Re: Matter No. 21-01188 – In the Matter of the Indian Point Closure Task Force and Indian Point Decommissioning Oversight Board.

- (1) Email from Holtec responding to questions from DOB Board member Richard Webster (PDF p. 2) dated August 30, 2022;
- (2) Email from Holtec responding to questions from Hudson River Sloop Clearwater (PDF p. 5) dated August 31, 2022;

From: [Richard Burroni](#)
To: [Richard Webster](#)
Cc: [Kaczmarek, Thomas \(DPS\)](#); [Congdon, Thomas \(DPS\)](#); [David Lochbaum](#); [Richard Burroni](#)
Subject: DOB Questions
Date: Tuesday, August 30, 2022 7:40:53 AM
Attachments: [image001.jpg](#)

From: [Richard Burroni](#)
To: mannajo@clearwater.org
Cc: [Richard Webster](#); [Victoria Leung](#); [Kaczmarek, Thomas \(DPS\)](#); [Congdon, Thomas \(DPS\)](#); [Don Mayer](#); [Richard Burroni](#)
Subject: Response to Manna Jo Greene email dated 8/20/"22
Date: Wednesday, August 31, 2022 2:26:27 PM
Attachments: [FW Updated - DOB 03-17-22 - NYS Pollutant Discharge Elimination System.msg](#)
[Report on water filtration.msg](#)

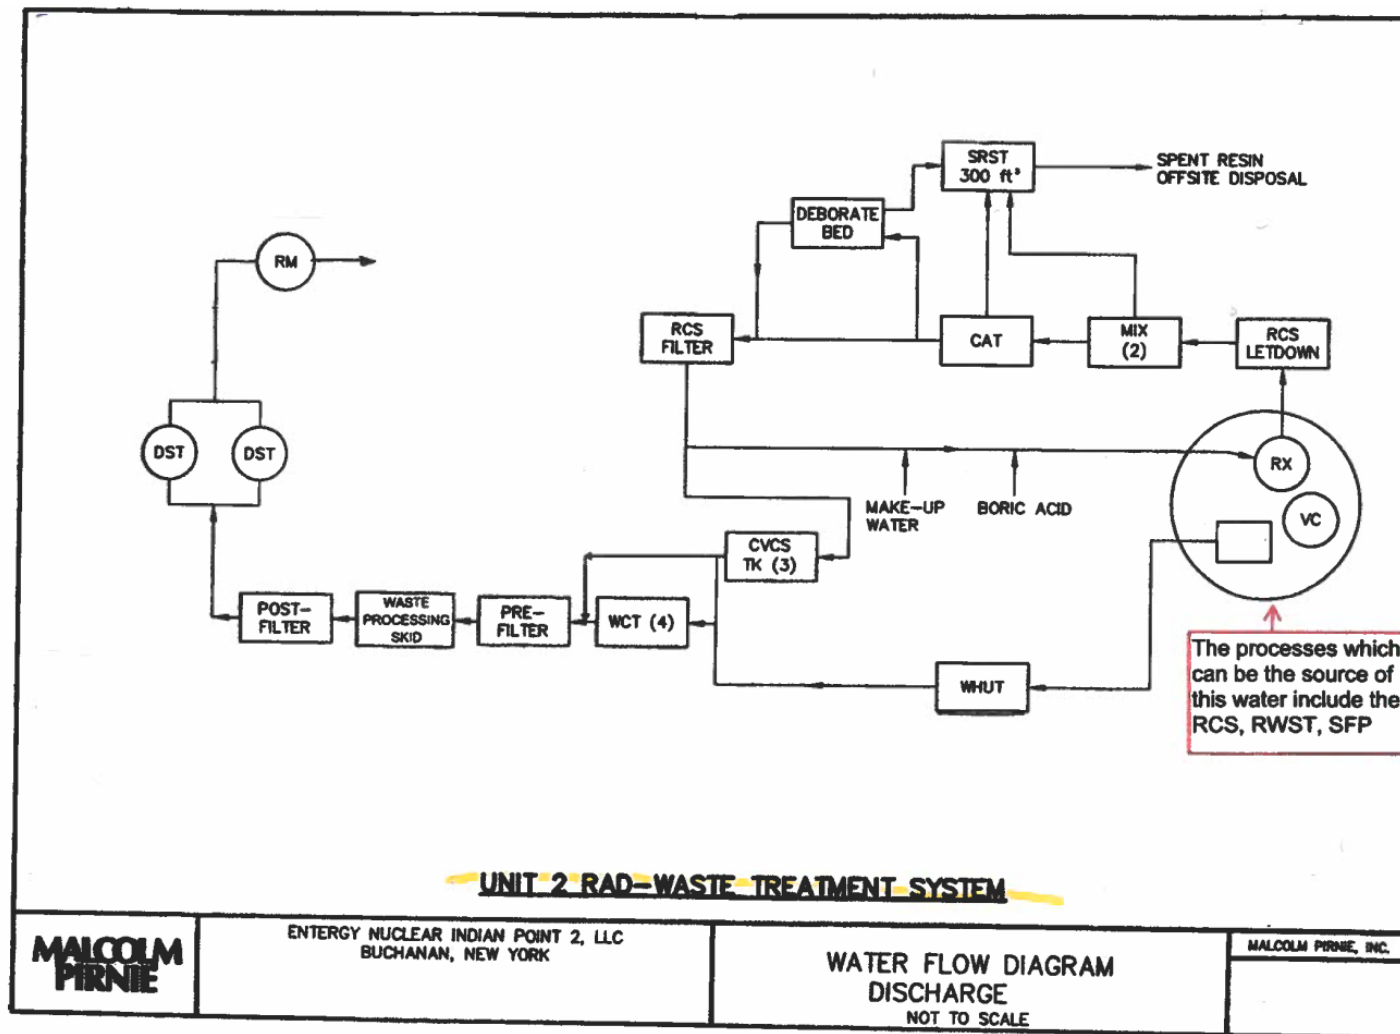
No water from the Processed Waste Streams are directly discharged to the river. With the exception of the North Curtain Drain, this water is filtered, housed in collection tanks, circulated, analyzed then discharged. See attached simplified diagram. North Curtain Drain water is filtered and analyzed prior to discharge.
